Response to U.S. EPR Design Certification Application RAI No. 422, Supplement 30

**Response to
Request for Additional Information No. 422(4792)**

**U.S. EPR Standard Design Certification
AREVA NP Inc.
Docket No. 52-020
SRP Section: 03.09.02 - Dynamic Testing and Analysis of Systems Structures and
Components
Application Section: 3.9.2**

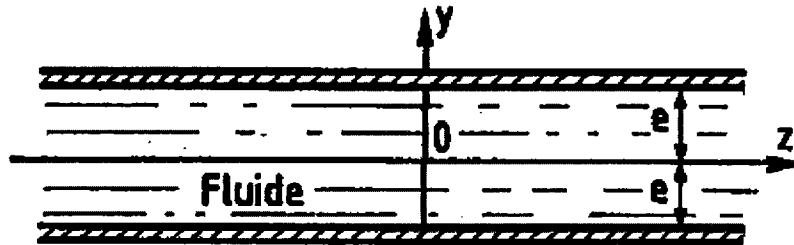
The staff noted that the applicant described viscous damping was the only mechanism found to contribute to the shell modes. The contribution of viscous damping over the frequency band of 2.5 to 10 Hz was calculated using formulation by R. J. Gibert. The staff noted that the cited reference has not been used by other applicants. The applicant is requested to provide documentation that the methodology is an approved industry approach accepted by the NRC or an alternate source for this calculation.

The formula for shell-type mode damping as proposed by R.J. Gibert is selected because it adequately corresponds with the damping associated with the flexural vibration of fluid-coupled plates. The full derivation of the solution and the equation for the viscous damping, as reported in Technical Report ANP-10306P, Section 4.2.5.3.4, including all hypotheses and simplifications, is provided in Chapter 15 of Reference [1].

As requested by the NRC during a teleconference held on December 16, 2010, the methodology for this damping is translated from French to English to assist in the review of the Technical Report ANP-10306P. The following methodology for shell-type damping is a translation of Example 15.2.4 from Reference [1].
